Attorneys for Hecla Limited Lucky Friday Mine

IN THE MATTER OF:)
)
HECLA LIMITED LUCKY FRIDAY UNIT) CASE NO. _____
NPDES PERMIT NO. ID0000175; IDEQ 401)
CERTIFICATION (June 3, 2019)) PETITION TO INITIATE CONTESTED
) CASE AND REQUEST TO STAY 401
) CERTIFICATION
)
_____)

**PETITION TO INITIATE CONTESTED CASE AND
REQUEST TO STAY 401 CERTIFICATION**

Figure 1. Stream Flow and Hardness Relationship

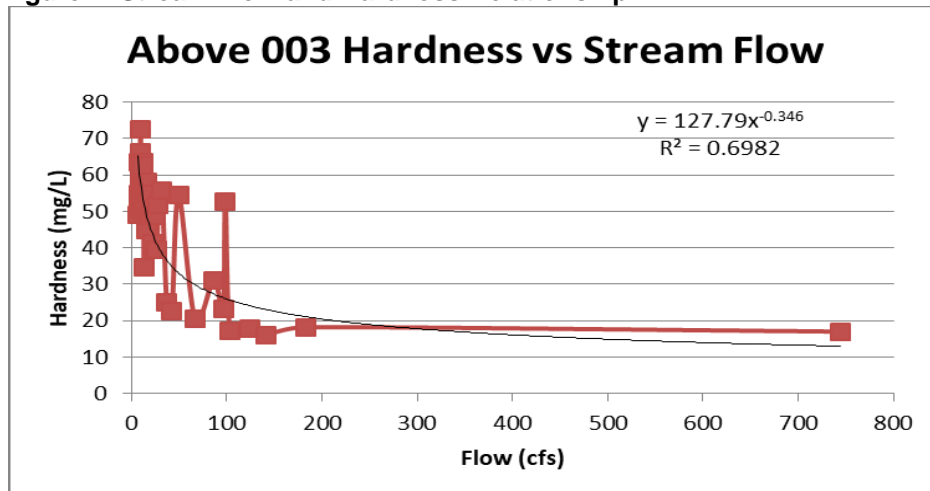
Comment #34, Appendix C.Part A(Page 69): As per the draft Fact Sheet, receiving stream hardness occurring at low flow conditions (i.e, 1Q10, 7Q10) was estimated based by plotting flow versus hardness data, collected upstream of Outfall 002 and 003 and is shown in Figures C-1 and C-2 of the Fact Sheet. As discussed in the *Idaho Mixing Zone Implementation Guidance*, use of such method is acceptable for estimating hardness at low flow for hardness-based metals criteria calculations. However, the statistical relation between hardness and flow should be determined by a nonlinear regression, as noted in the Guidance. While for Figure C-1 (Upstream of Outfall 002), low flow hardness was estimated from a regression using a polynominal trend line, a linear regression was used for Figure C-2, which was used to estimate the hardness of 49.8 mg/L at the 1Q10 and 49.7 mg/L at the 7Q10, for upstream of Outfall 003. The R² value for this linear regression is only 0.2897, which indicate low relationship between the trend line and actual data. LFU suggests that for estimating low flow hardness upstream of 003, a non-linear regression should be used. Using upstream hardness and corresponding river flows for Outfall 003, Figure 1 below presents a more appropriate analysis of the relationship. Using a power regression type provides for a much higher R² value, indicating a more realistic estimate of hardness at low flow. Using the information in Figure 1 below results in estimated low flow hardness of 81 mg/L at the 1Q10 flow of 3.7 cfs and 72 mg/L at the 7Q10 of 10.9 cfs (low flows as per Fact Sheet). Therefore, LFU requests the Figure C-2 be revised to utilize the more appropriate regression type and resulting estimated hardness.

Figure 1. Stream Flow and Hardness Relationship

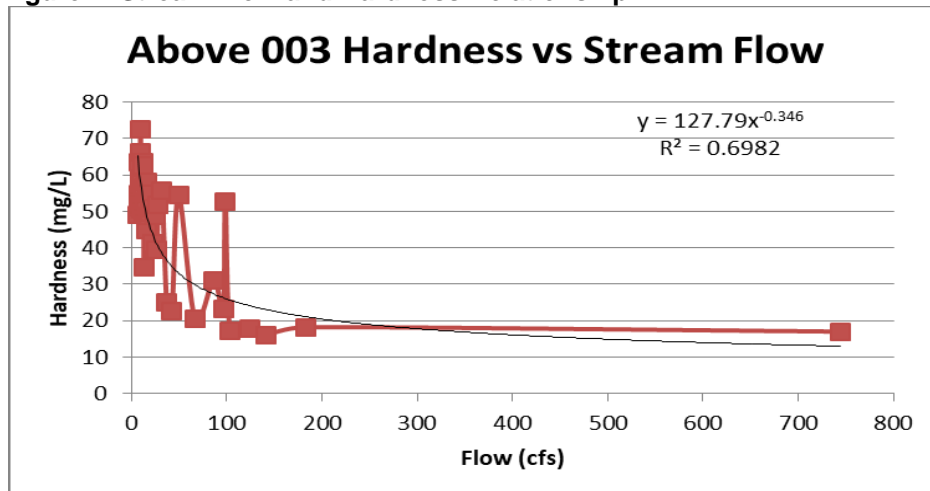
Comment #34, Appendix C.Part A(Page 69): As per the draft Fact Sheet, receiving stream hardness occurring at low flow conditions (i.e, 1Q10, 7Q10) was estimated based by plotting flow versus hardness data, collected upstream of Outfall 002 and 003 and is shown in Figures C-1 and C-2 of the Fact Sheet. As discussed in the *Idaho Mixing Zone Implementation Guidance*, use of such method is acceptable for estimating hardness at low flow for hardness-based metals criteria calculations. However, the statistical relation between hardness and flow should be determined by a nonlinear regression, as noted in the Guidance. While for Figure C-1 (Upstream of Outfall 002), low flow hardness was estimated from a regression using a polynominal trend line, a linear regression was used for Figure C-2, which was used to estimate the hardness of 49.8 mg/L at the 1Q10 and 49.7 mg/L at the 7Q10, for upstream of Outfall 003. The R² value for this linear regression is only 0.2897, which indicate low relationship between the trend line and actual data. LFU suggests that for estimating low flow hardness upstream of 003, a non-linear regression should be used. Using upstream hardness and corresponding river flows for Outfall 003, Figure 1 below presents a more appropriate analysis of the relationship. Using a power regression type provides for a much higher R² value, indicating a more realistic estimate of hardness at low flow. Using the information in Figure 1 below results in estimated low flow hardness of 81 mg/L at the 1Q10 flow of 3.7 cfs and 72 mg/L at the 7Q10 of 10.9 cfs (low flows as per Fact Sheet). Therefore, LFU requests the Figure C-2 be revised to utilize the more appropriate regression type and resulting estimated hardness.

BLM-based Criteria Comparison

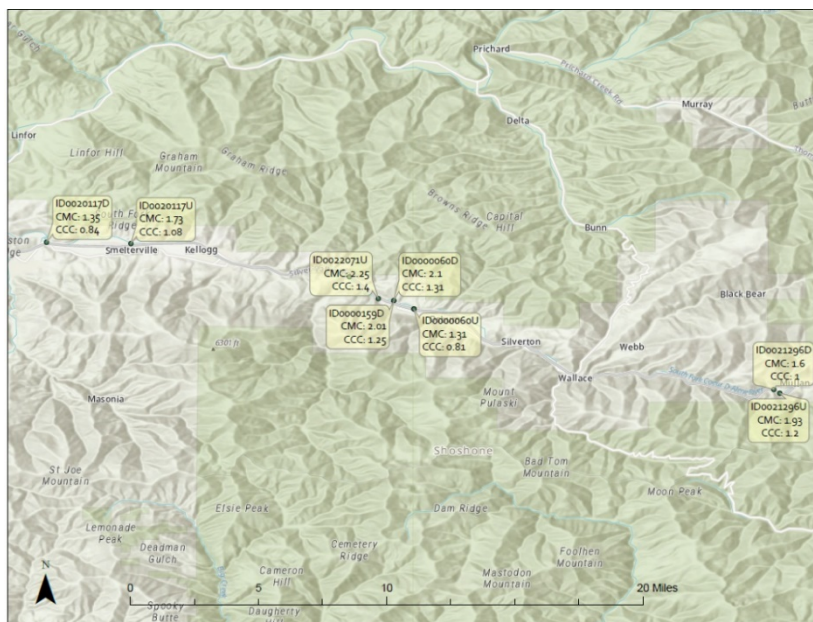
- The Mountain Stream class criteria are overly conservative for the SFCdAR near LFU. The Draft Fact sheet (pg. 71) notes that background concentrations of Cu are higher than the BLM criteria, with the average dissolved copper concentration of 1.21 ug/L above Outfall 002 and 0.69 ug/L above Outfall 003 over the monitoring period from 2012-2016. However, 10 years of site-specific bioassessment data show stream aquatic community equal to regional reference streams, indicating the Mountain Stream criteria are likely overly conservative. Based on the above discussion, LFU requests that the approach to use default regional input values for calculating the copper BLM-based effluent limits be reconsidered. LFU requests that the hardness-based copper effluent limits remain effective until after adequate site-specific data can be collected and site specific BLM criteria can be calculated during the five year compliance schedule period. Additionally, as per the Implementation Guidance for the Idaho Copper Criteria for Aquatic Life (2017), flow-tiered NPDES permit limitations are an acceptable implementation tool for copper Biotic Ligand Model (BLM)-based limits. Due to the extremely low BLM-based criteria and potential variability of BLM input parameters, LFU requests that flow-tiered limits be considered when defensible site-specific BLM based effluent limits are established in the Permit.

Response: The Fact Sheet specified that the BLM based effluent limitations would only be included in the final permit if EPA approved DEQ’s submission of the new WQS prior to EPA finalizing the permit. This approval occurred on May 2, 2019. Therefore, the applicable WQS in place for CWA purposes is the copper BLM WQS. The Fact Sheet also stated that since the ambient background concentration of copper exceeded the BLM criteria, no mixing zone could be authorized for copper.

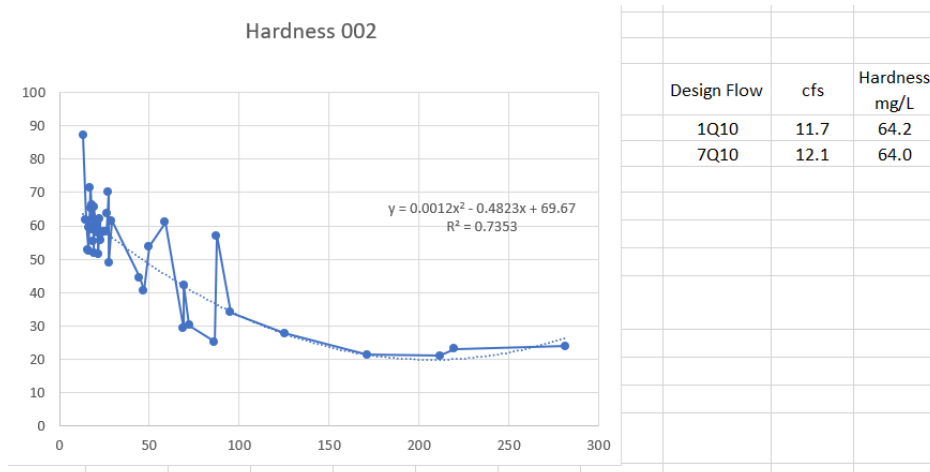
35. **Comment:** Please explain why EPA declined to analyze the full record of monitoring data for receiving water quality, outfall flow rate, effluent characterization, and critical low flow. EPA's Fact Sheet indicates the following analyses were based off varying date ranges of monitoring data Hecla collected pursuant to its current NPDES permit:

Hecla's current NPDES permit was issued in 2003. So, EPA has the benefit of well over a decade of monitoring data that should inform the development of Hecla's updated permit. For example, analyzing another year's worth of data (or more) could change EPA's calculation of the 99th percentile outfall flow rate. Similarly, another year's worth of data (or more) could reveal higher or lower potential maximum and minimum constituent levels in Hecla's effluent. And, changes to either or both of these variables could significantly affect EPA's determination of effluent limits and monitoring requirements. But rather than analyze all the data, EPA chose to limit its analysis to 4 years of data in some cases, without providing a reasonable basis for this decision.

We request EPA re-analyze receiving water quality, outfall flow rate, effluent characterization, and critical low flow based on the complete record of Hecla's monitoring data recorded since its current permit became effective.
